CAP 661

Mandatory Permit Directives

For Aircraft Operating on a Permit to Fly

REVISION TRANSMITTAL SHEET ISSUE NO 2011/2 DATED JULY 2011

Figure 1

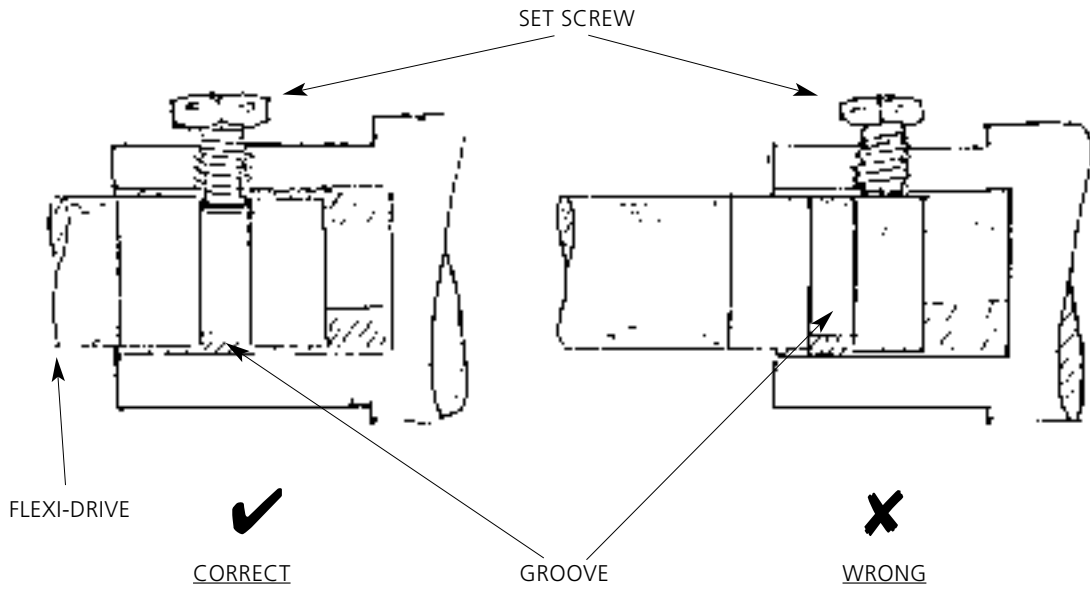
- (a) Remove the set screw, having first noted the amount of aluminium end ferrule projecting from the end socket. This should correspond with the distance of the centre line of the tapped hole normally occupied by the set screw from the face of the socket. If these dimensions do not correspond, the flexible drive shaft is incorrectly fitted, as it is possible to clamp the drive shaft ferrule at positions away from the groove in such a way that the drive is held by friction instead of positively located by the set screw in the groove. (See Figure 1).

- (b) Check that the set screw has a flat face at the threaded end. If it has a domed end like a normal bolt, this must be refaced to allow full engagement in the groove in the ferrule. (See Figure 2).

Figure 4 Pre-Rotator Drive Safety Strap

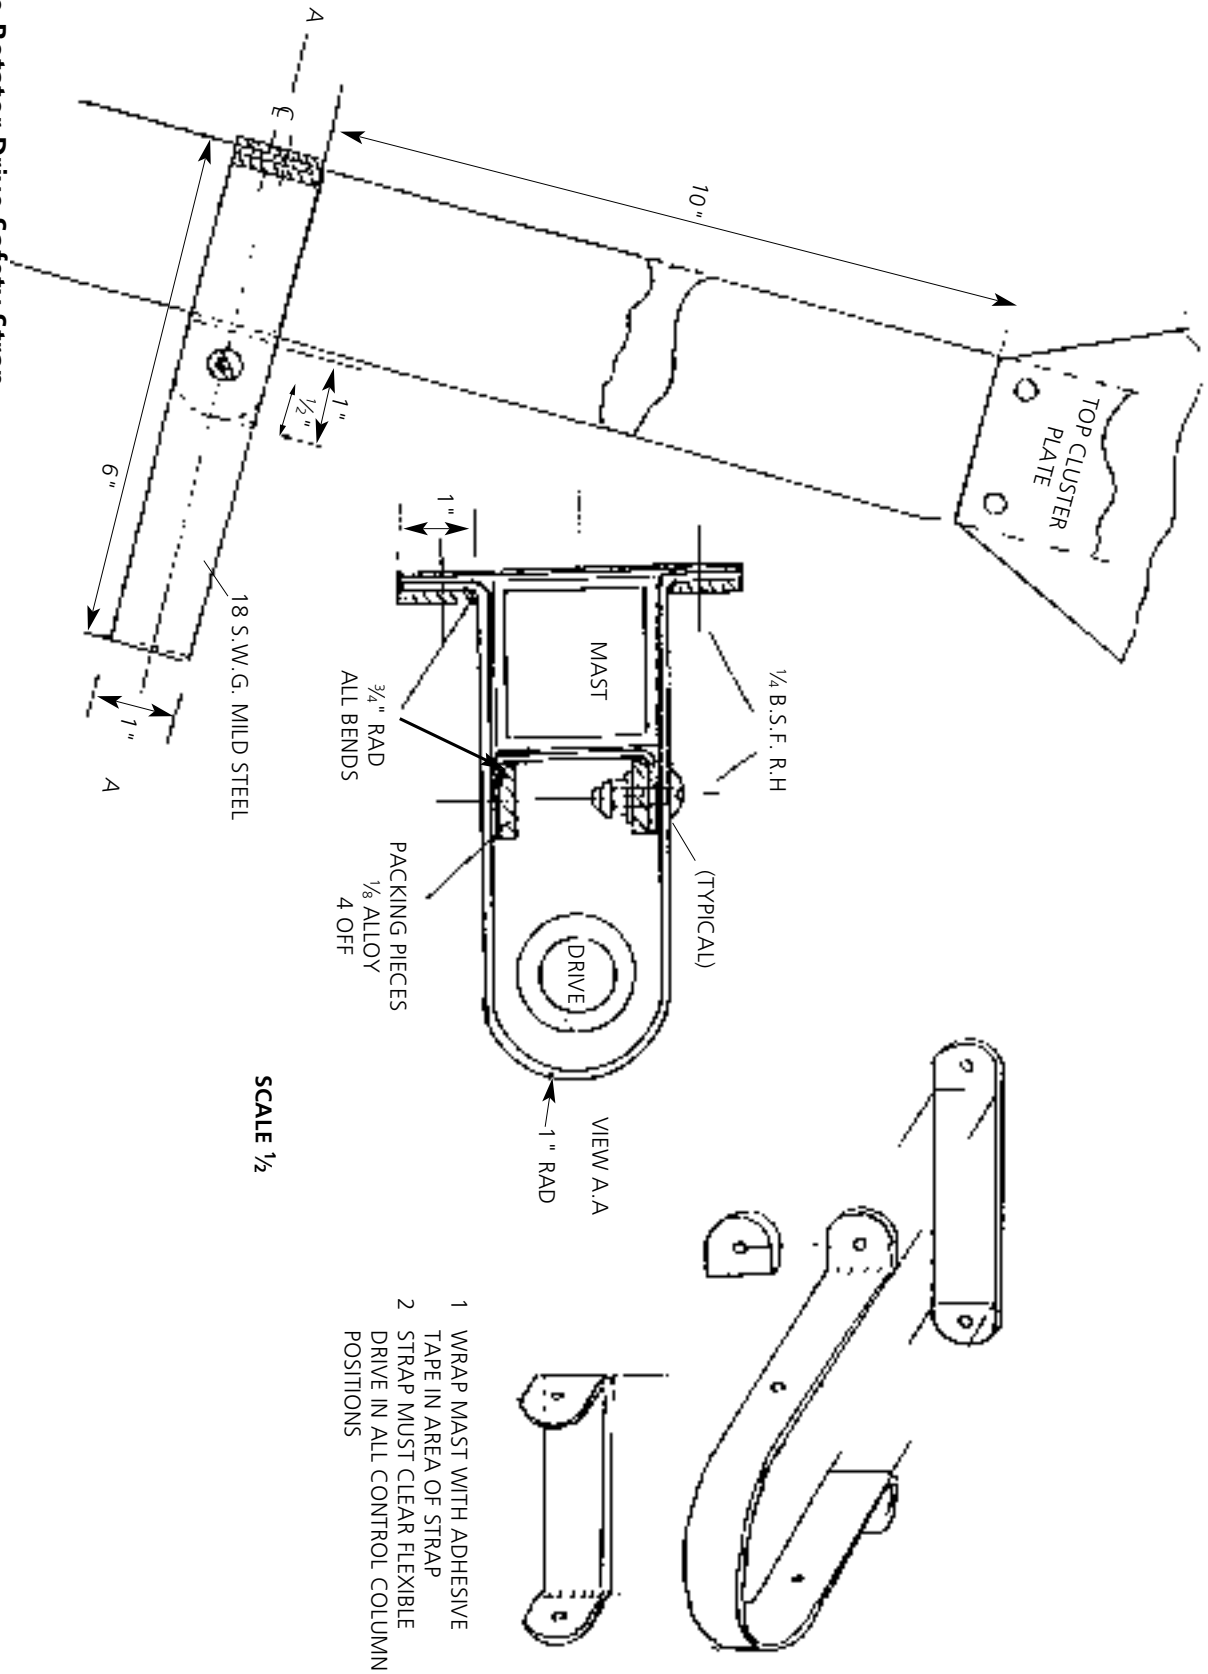
- 2 Check that the flexible drive shaft is correctly restrained in position on the aircraft by a safety collar mounted on the rotor pylon positioned approximately 10" below the rotor head cluster plates. (See Figure 3). This safety collar is a loose fit around the shaft which must be able to move freely up and down as the flying controls are moved. (See Figure 4).

Figure 1

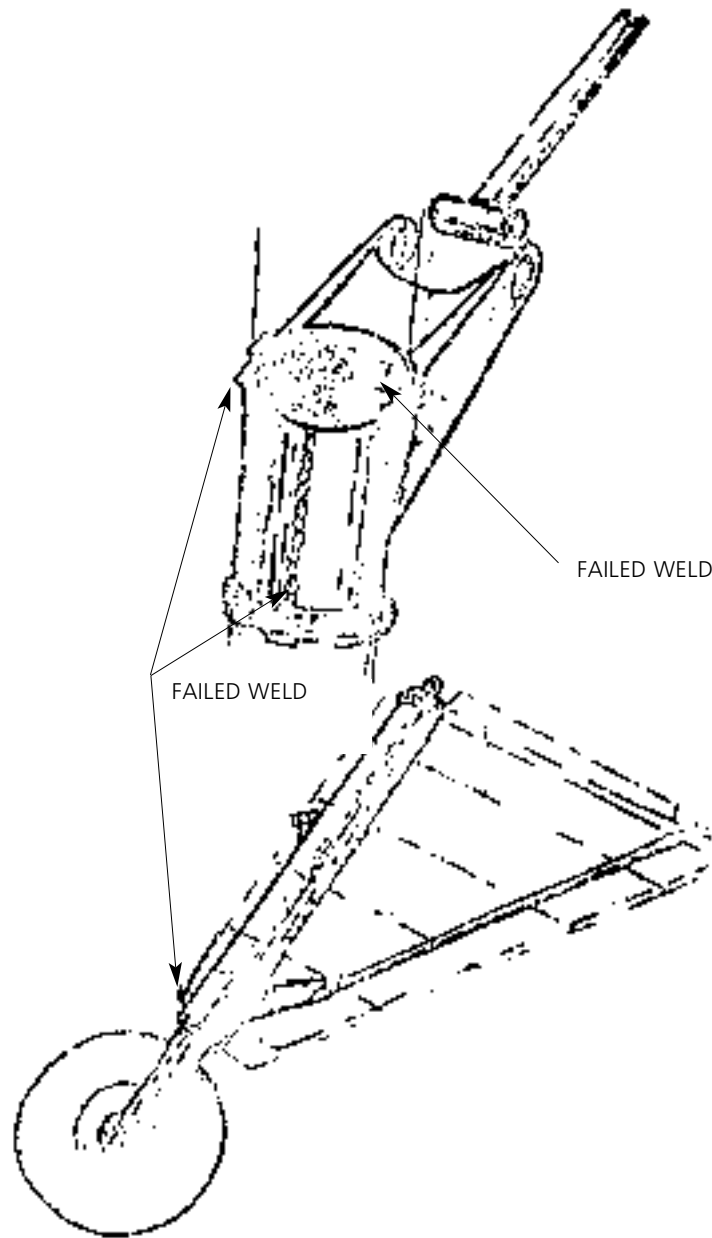
Compliance: At the next opportunity and thereafter following any heavy landing and at each Permit to Fly renewal inspect the landing gear welds for cracking. (See Figure 1 overleaf).

Figure 1
Avon Mk. 203 & Mk. 207
Right hand auxiliary gearbox drive

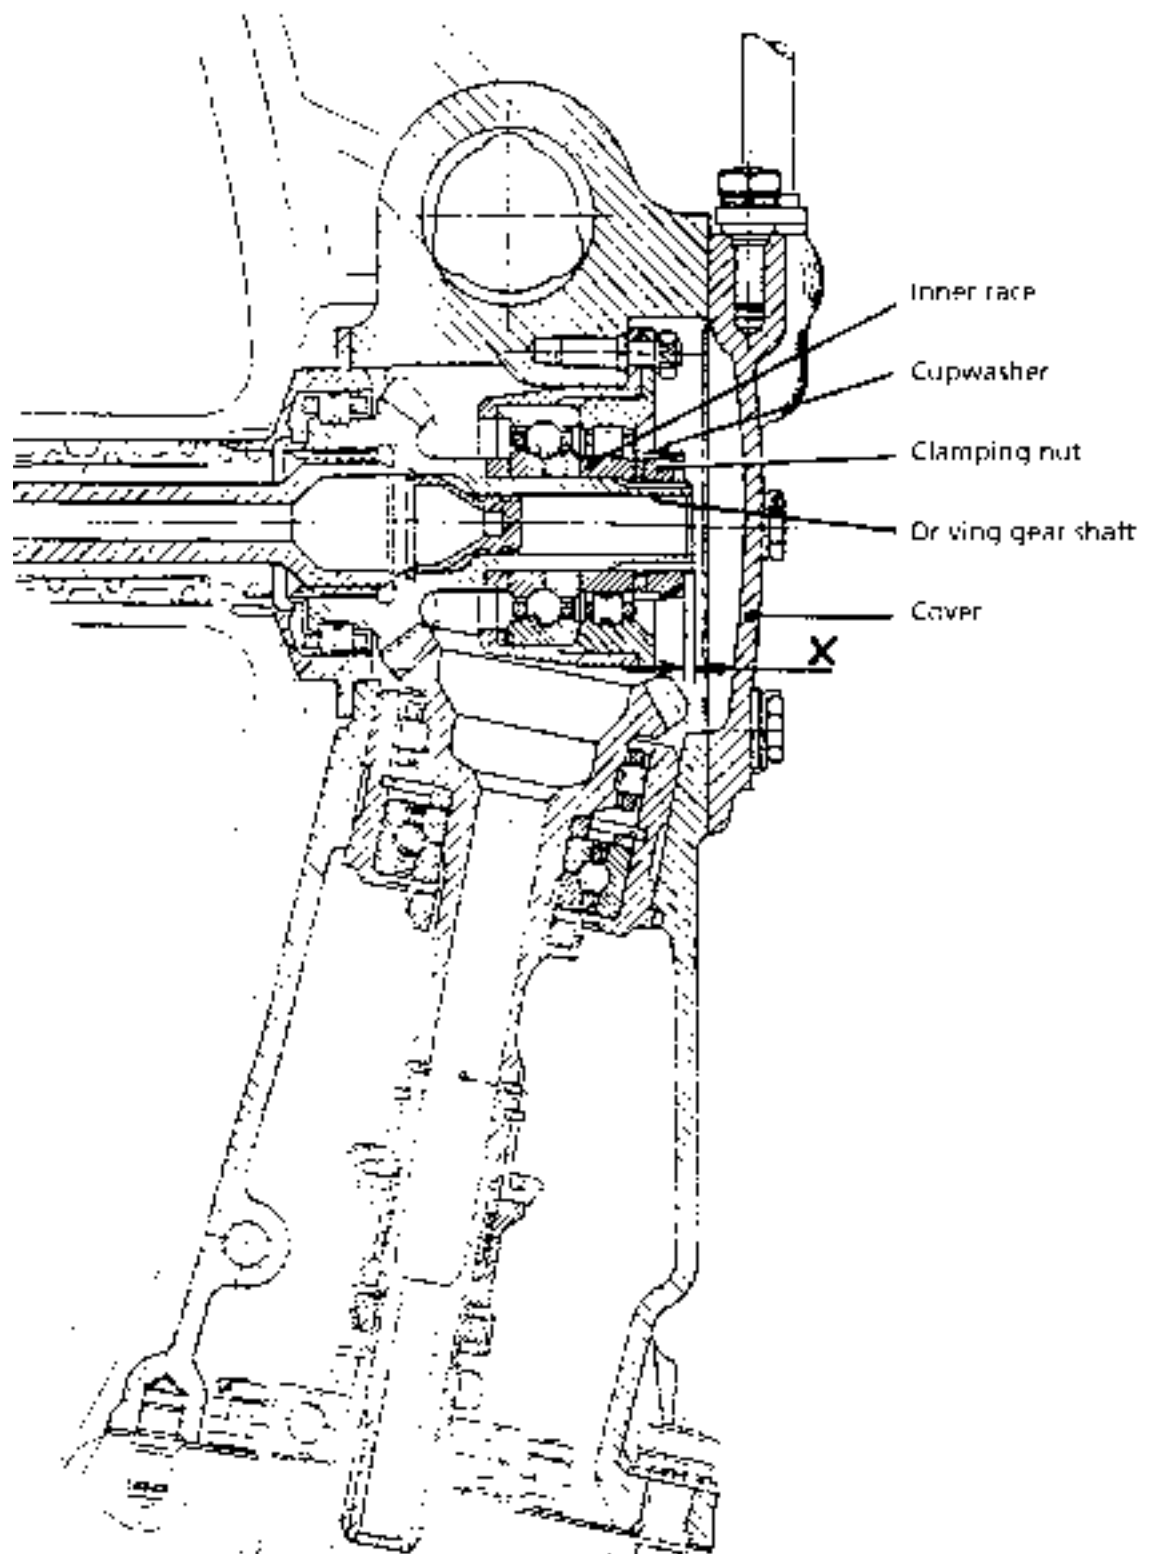
- 4 Measure the protrusion of the end face of the shaft from the end face of the nut (dimension X in Figure 1). If this dimension is 0.120"(3.0 mm) or less, the cover can be replaced, using new tabwashers and fresh jointing compound and the engine returned to service.
- 5 If the dimension is greater than 0.12"(3.0 mm) this is an indication that the inner race may be missing and the gearbox is to be removed before further flight. If, on subsequent strip, the inner race is found to be missing, the bevel gear drive train is to be replaced before being refitted to an engine. (See Note 2).

Figure 1 Plan view of Augmentor and By-Pass Valve Joint Washer

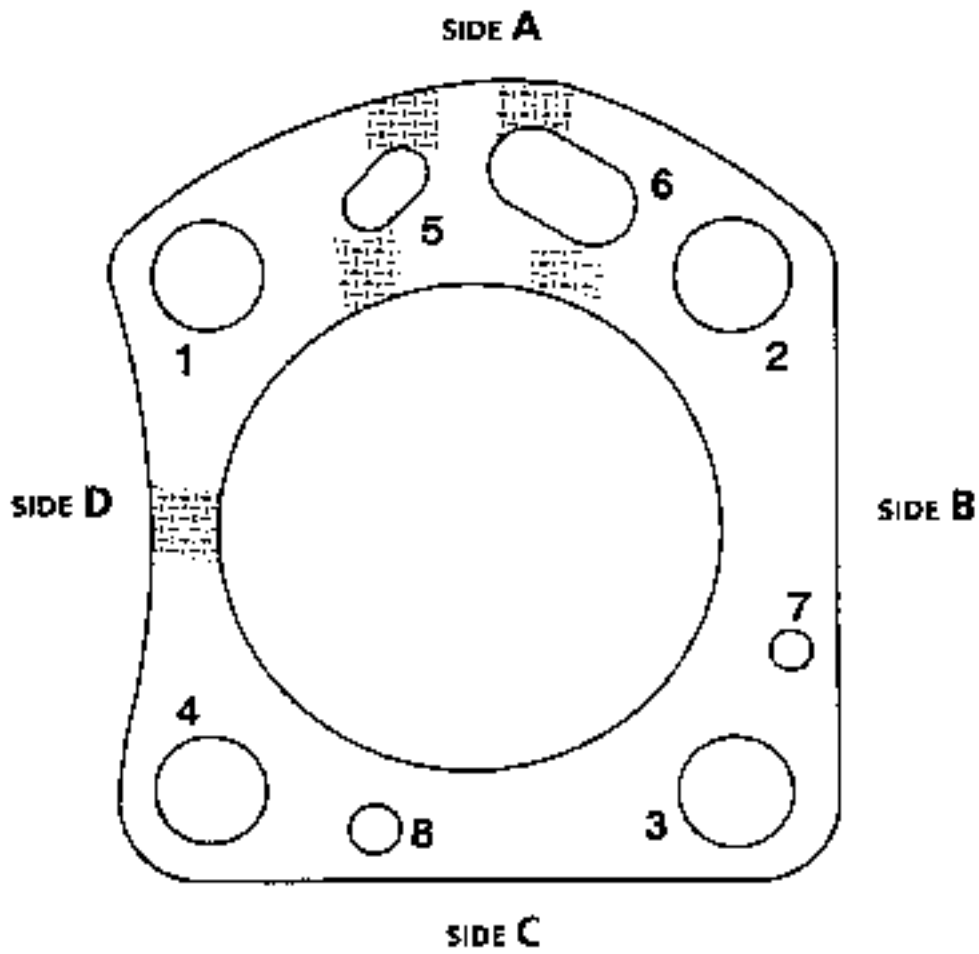
Internal 'stray wires' produced in the manufacturing process, completely contained within the joint washer material and revealed by the x-ray inspection, are acceptable between holes 2 and 3 and holes 3 and 4 (refer to figure 1). Internal 'stray wires' are not acceptable between holes 1 and 2, and holes 1 and 4.

The alignment/waviness of the stainless steel matrix should be parallel within plus or minus 10 degrees relative to sides B or C (refer to figure 1). Variations between these limits at any position on the joint washer are permissible, provided that such variations are in the form of smooth curves or waves, with no more than one wave across the width or depth of the joint washer. Local variations to a maximum of plus or minus 20 degrees are permissible at the following positions:

FIGURE 1

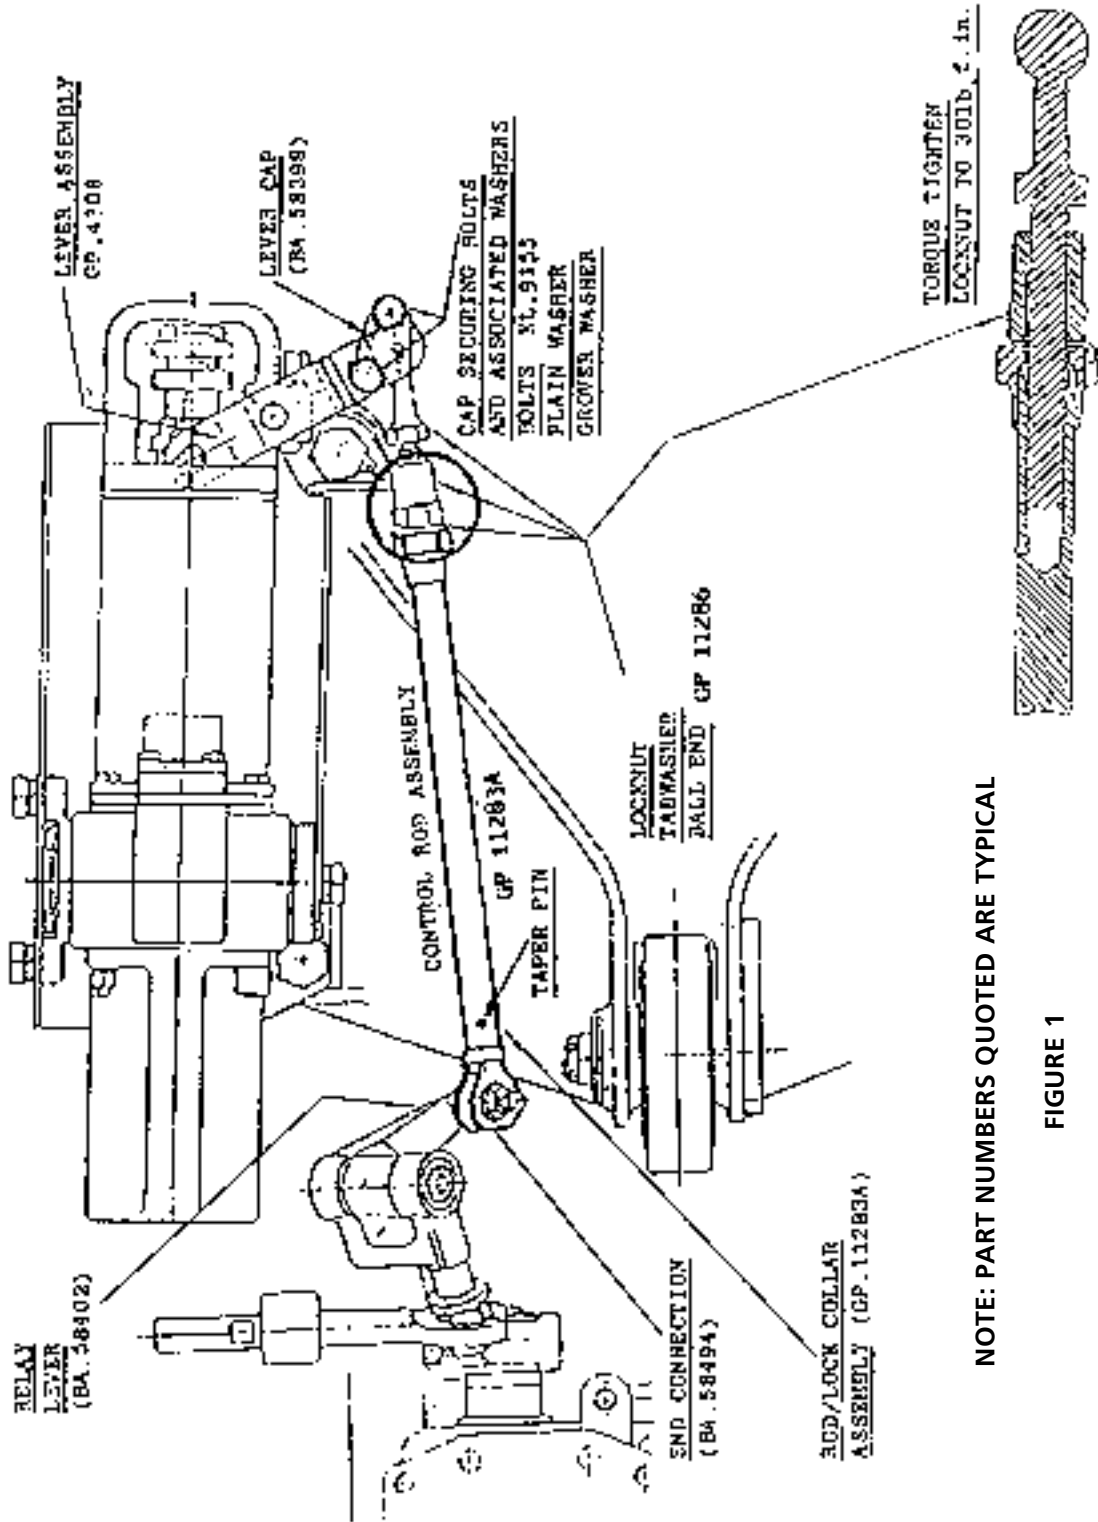
Reason: The CAA has recently been advised that an accident to a Hunter T7 in military service was attributed to disconnection of the top temperature controller control rod assembly (typical Part No. GP11283A) from its ball end piece (typical Part No. GP11286) (See figure 1). This disconnection led to loss of thrust control and eventual loss of the aeroplane. This MPD is issued to instruct a check on the assembly of the control linkage.

- 1 Gain access to the top temperature controller control rod assembly.
- 2 Examine the control rod for correct assembly.
- 3 Check the torque tightening on the nut securing the linkage. This torque should be a minimum of 30 lbf in as defined in STI/Avon/92. Do not disassemble the linkage if this torque level is satisfied.
- 4 If this torque level is not satisfied, inform the CAA, disconnect the assembly and inspect for signs of wear, or damage to the rest of the linkage. Evidence of wear or damage to the assembly is also to be reported to the CAA.
- 5 If no damage or wear is evident, reassemble the control linkage in accordance with instructions contained in AP 102-1512 to 1517-6A Section 2 Chapter 6 para 52-56B. STI/Avon/92 should also be consulted, since this contains necessary torque tightening information for the locknut.

MANDATORY PERMIT DIRECTIVE

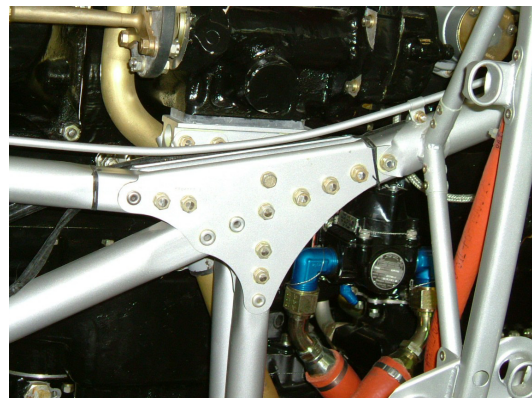
Reason: Cracks have been found in the engine mounting brackets of three Hurricane aircraft. A pair of brackets is installed on each side of the engine mount. The photographs below show the location of the cracks.

Cracks have been found in brackets of both the original design (part numbers A72086 and A72087) and the modified design (drawing AP1564B-M14-W/44). One aircraft was found to have cracks in three of the four brackets fitted. Brackets have been observed with plates attached to the outer surfaces of the triangular webs. If plates have been attached to the brackets, the inspection detailed in this MPD will not be effective and the CAA must be consulted for details of an appropriate inspection.

- b) If no cracks are found under a) or when the brackets are replaced with new brackets of either the original design (part numbers A72086 and A72087) or the modified design (drawing AP1564B-M14-W/44), inspect the brackets for cracks at intervals of 50 hours or every 24 months whichever is the shorter. If cracks are found during any of these inspections, the brackets are to be replaced with new parts. Note that if one bracket in a pair is found to be cracked, both brackets must be replaced.

Figure 1. General Arrangement of VPM M16 Fuselage Structure showing areas where cracks have been seen.

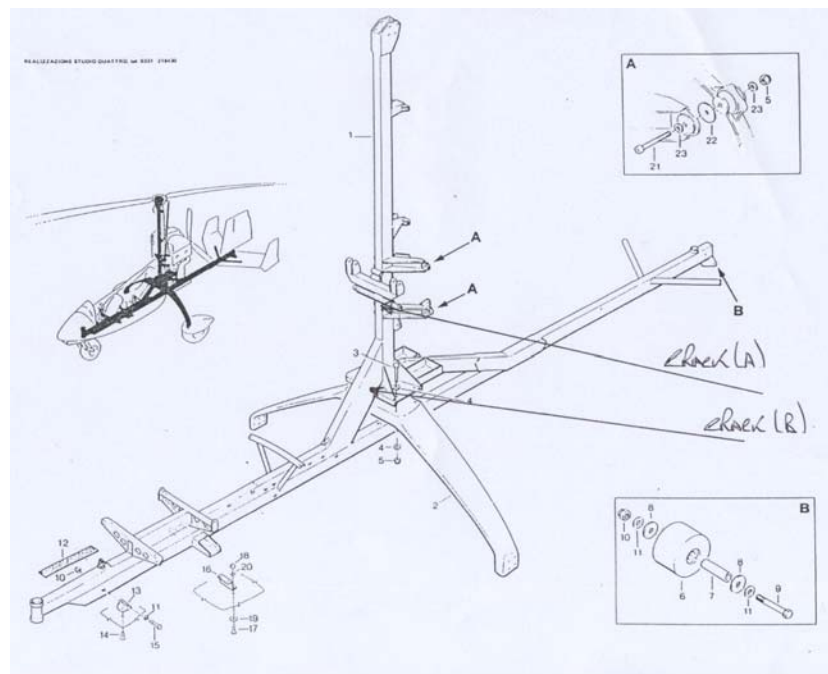
If cracks are found then the aircraft must not be flown and a full report submitted to the Light Aircraft Association. The manufacturers have indicated that a factory repair may be available on an airframe-by-airframe basis; advice should be sought from the UK agent (details overleaf).

If no cracks are found then the gyroplane may be returned to service.
